MAYFLOWER PLATINUM

Details of Additions & Alterations

Flat No	306	Block no.	'A'
Flat Area	1800 sft	Type	Deluxe / Luxury ✓
Buyer Name	Pradeep Kumar Nara		
Phone No.	9247802054	Email	Sandhyasani.2014@gmail.com

Description	Direction	Owners & Developers :	Date :	18.03.2020	Promoted by
WORKING DRAWING OF FLAT.NO.A-6		Modi Properties Pvt Ltd.	Prepared By :		Modi Properties Pvt. Ltd Phone:+91-40-66335551
		Project Name & Phase :	Approved By :	Soham Modi	
		MAYFLOWR PLATINUM	Scale :	N.T.S

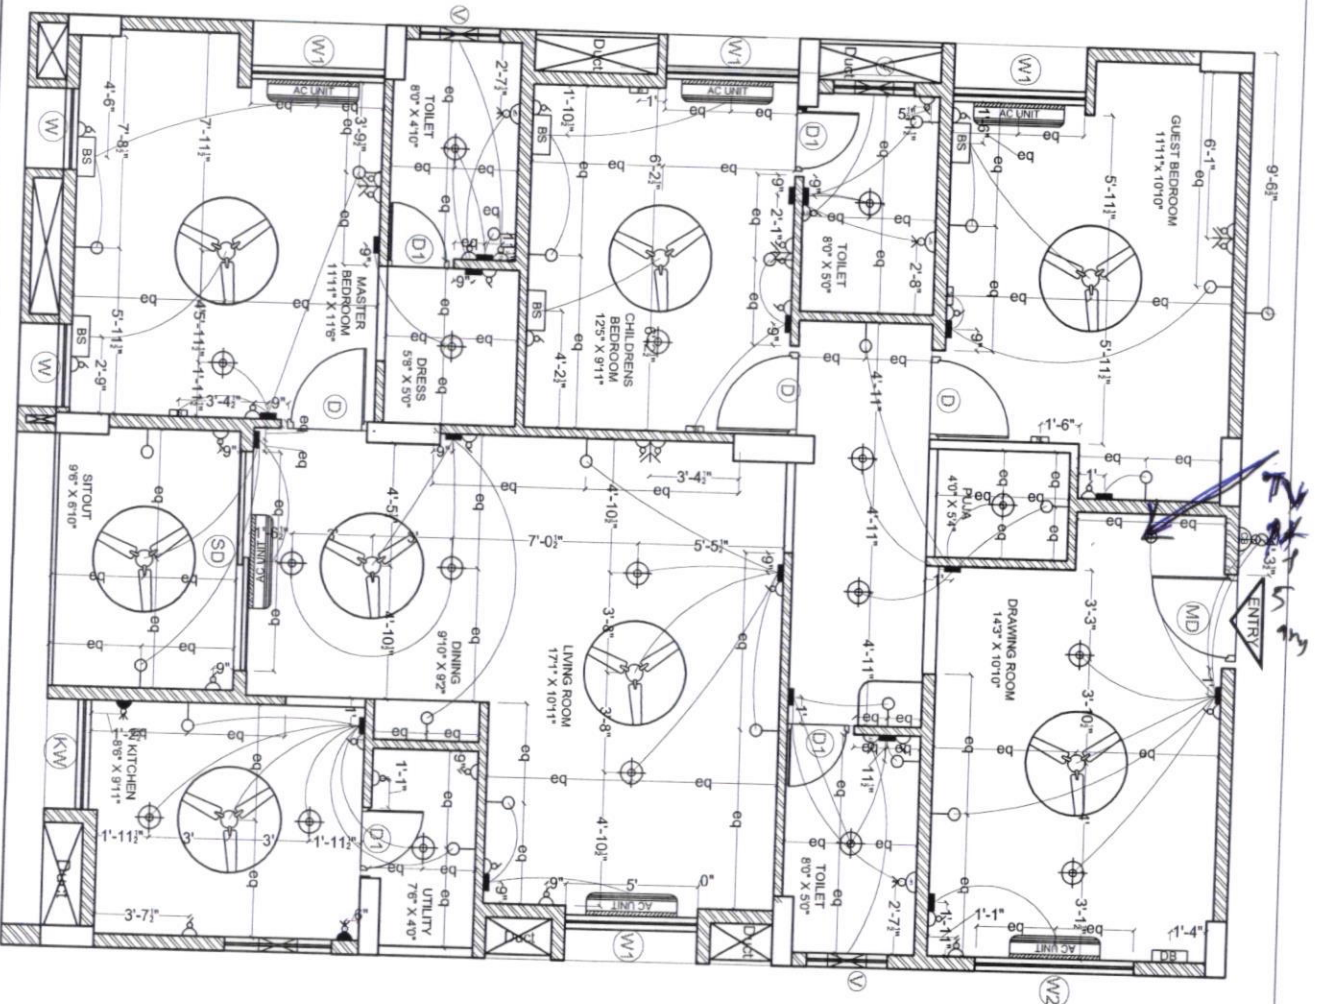
① CBR bathroom one extra door on east wall (marked on plan)

To be removed

Door to help provided

ELECTRICAL PLAN OF FLAT-A6

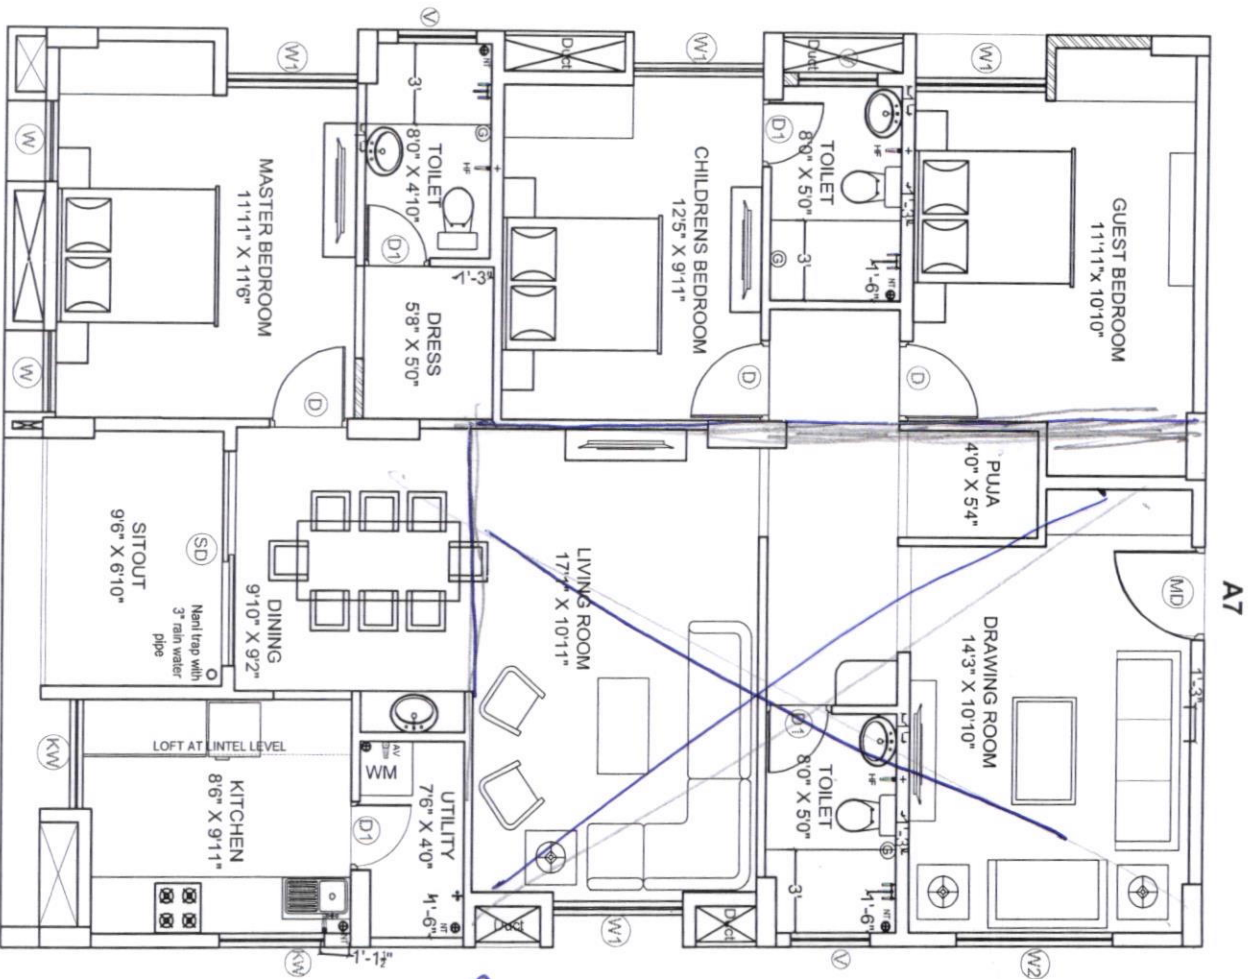
- ① Extra ^{5 amp} plug point at Drawing room wall
- ② TV port at Drawing room west wall
